**AGENDA
TECHNICAL REVIEW COMMITTEE
REGULAR MEETING
SEPTEMBER 25, 2025
10:00 AM
CITY HALL COMMISSION CHAMBERS
204 ASH STREET
FERNANDINA BEACH, FL 32034**

- 6. OLD BUSINESS**
- 7. NEW BUSINESS**
 - 7.1 **2025-0007_SHAYCORE LLC, AGENT FOR OCEAN COAST FERNANDINA, LLC, 2707 SADLER ROAD**
Site Review for previously presented project (see TRC 2023-0041) for the renovation of the ClubHouse and Administration building, renovation and repair to interior Guest Rooms, and reconstruction of Pool and Amenity.

OCEAN COAST HOTEL RENOVATION PERMIT SET - CLUBHOUSE

SHEET:
C020

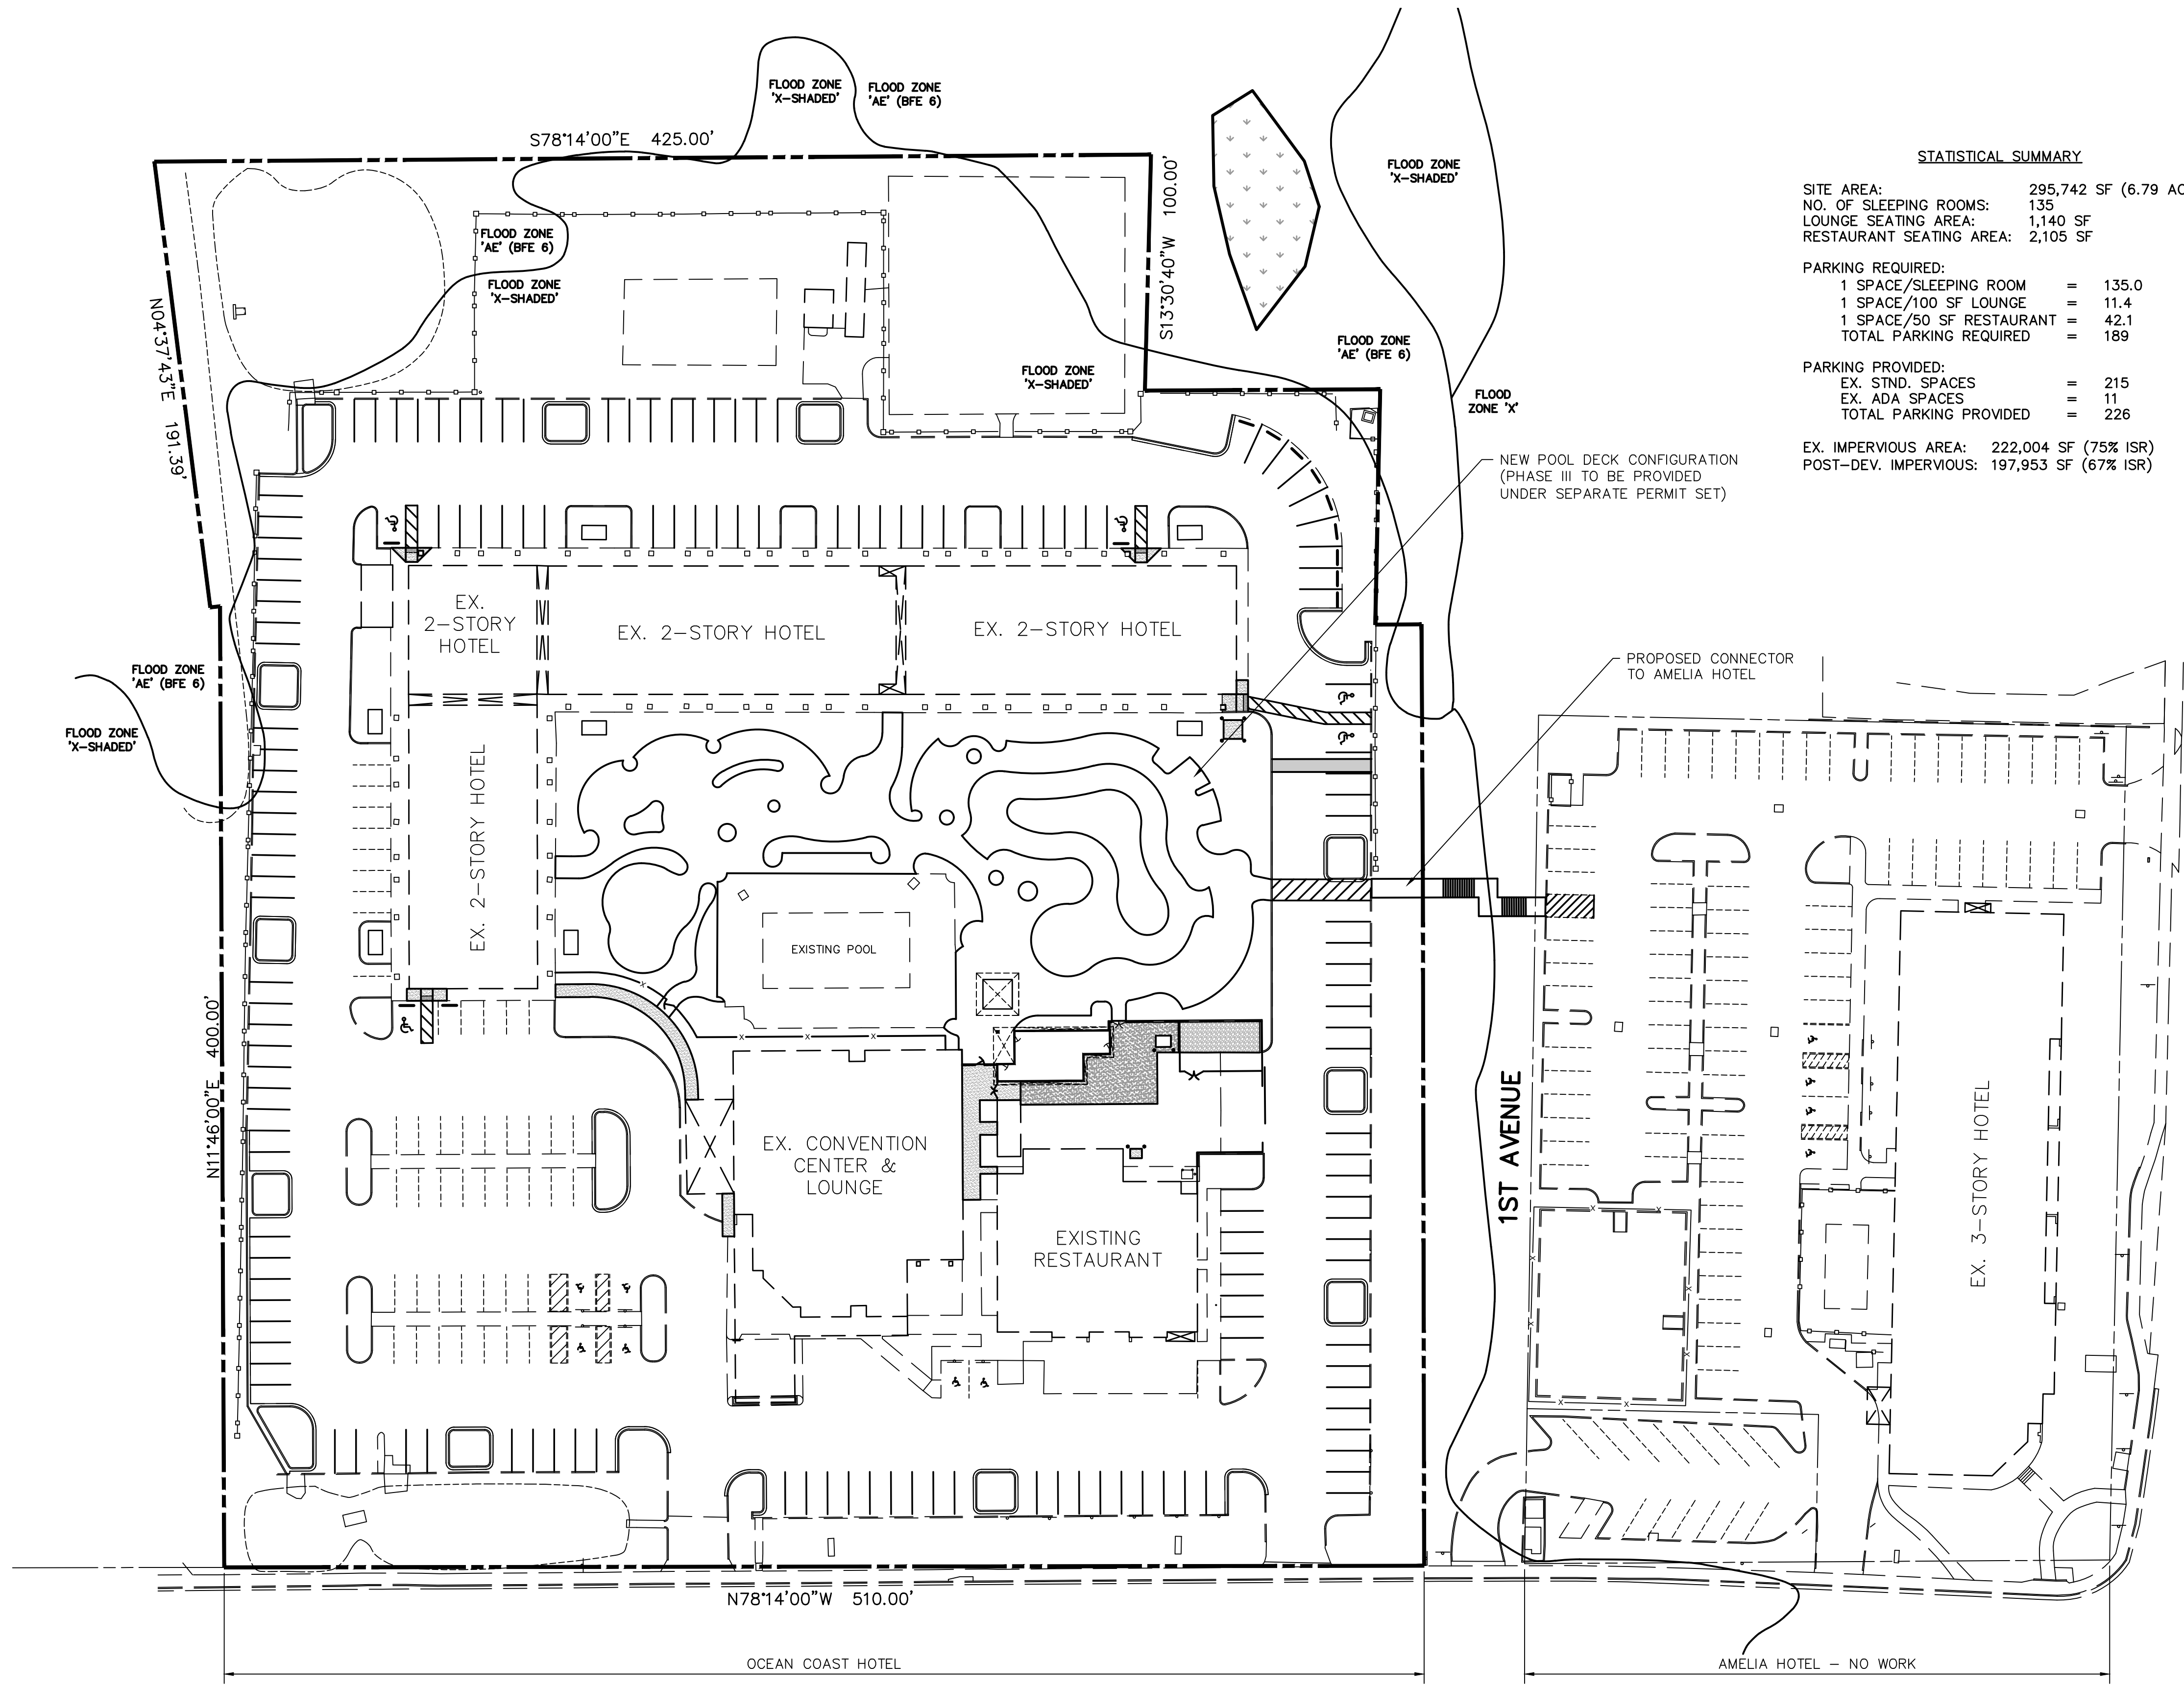
A detailed breakdown can be found on civil plan sheet C020 regarding the parking that will be removed, as well as the existing parking that will stay. Since the parking spaces are not numbered, could you please verify that the 225 remaining parking spaces are entirely situated on the parcel? This should also confirm that these spaces do not include any on the adjacent property, which is indicated as being linked by a proposed boardwalk. Please verify the timeline for Boardwalk? Additionally, there is a mention of SheetA-501 for the Boardwalk, but Sheet A-501 is not provided.

Response: Revised civil drawings are enclosed that provide further breakdown of parking counts, including currently existing and to be removed. See clouded notes.

PHASING PLAN
1
G-003
1" = 60'-0"

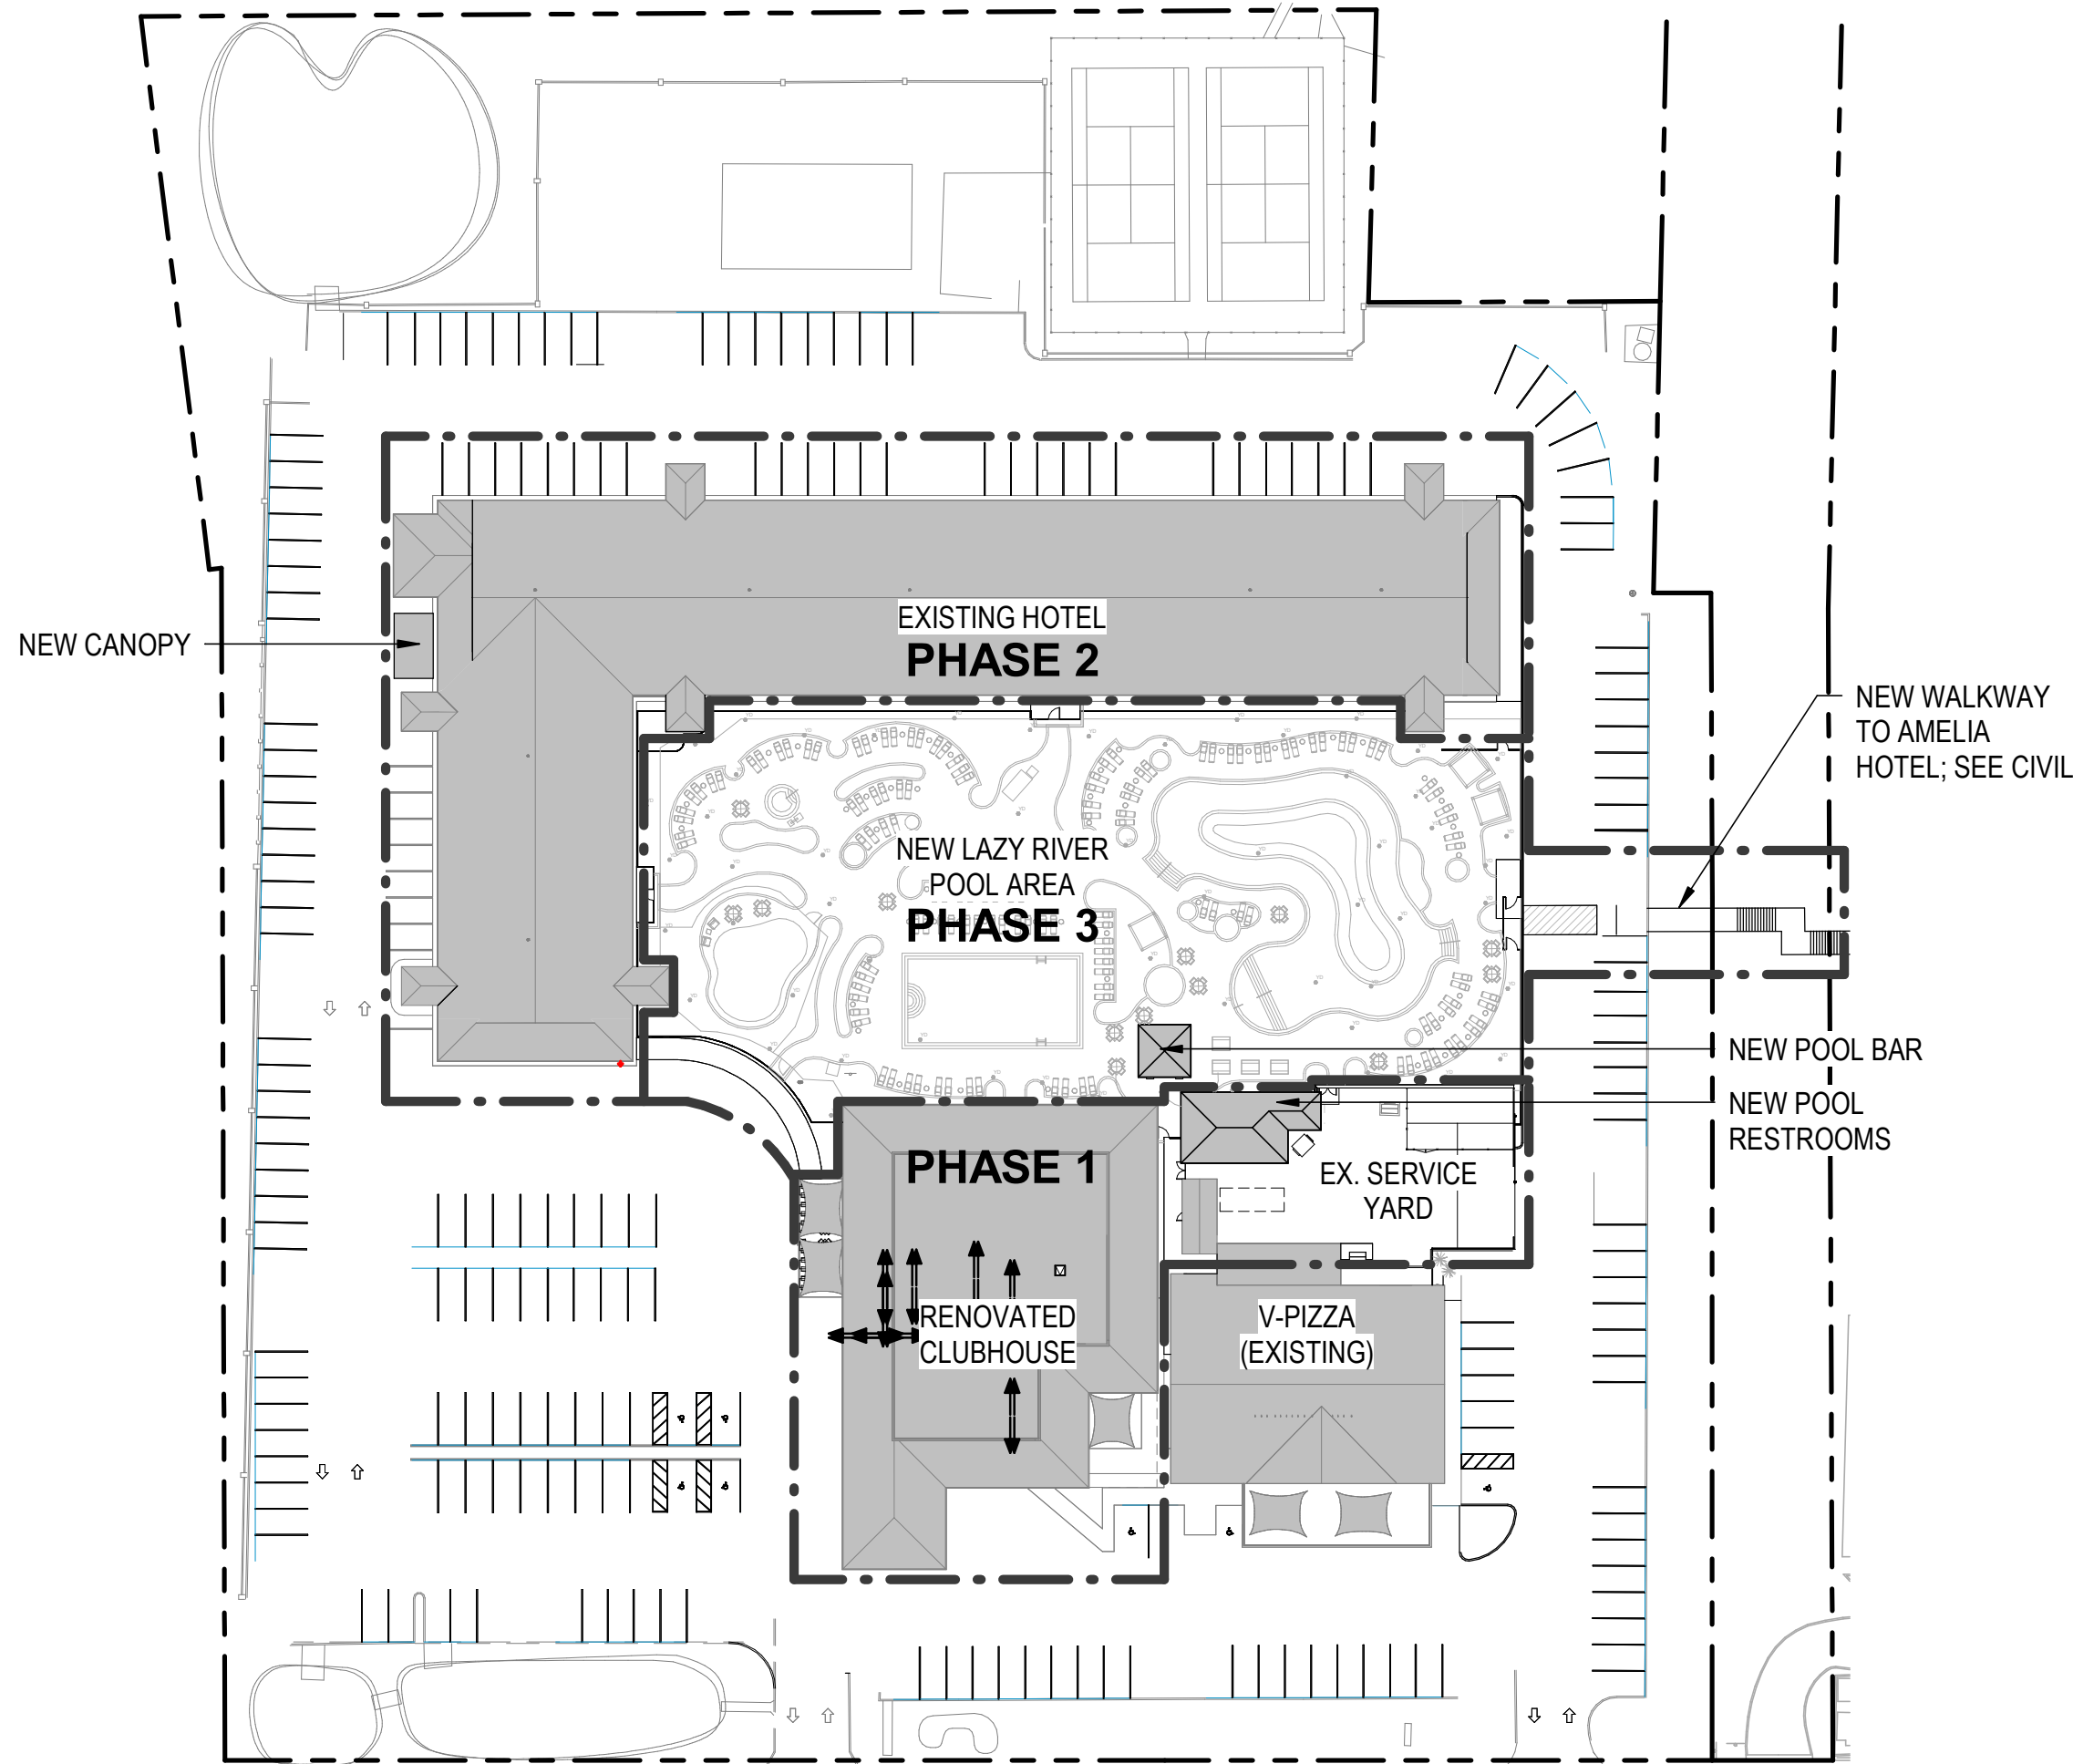
The architectural designs have been updated to show that the project will not be phased. Nevertheless, the civil plan indicates that the new pool layout is scheduled for phase 3. Could you please verify the timeline for the demolition of the existing pool and the construction of the new pool?

Please outline the narrative regarding the tasks to be completed in this phase of the project. The architectural plans indicate the phasing, whereas the civil plans do not reflect this. Based on the civil plans, certain activities, such as the demolition of the existing parking in Phase 3, are currently underway; however, there are no architectural plans available for Phase 3.

Response: The project was originally going to be constructed in phases. However, this is no longer the case, as all aspects of the project will be constructed concurrently.
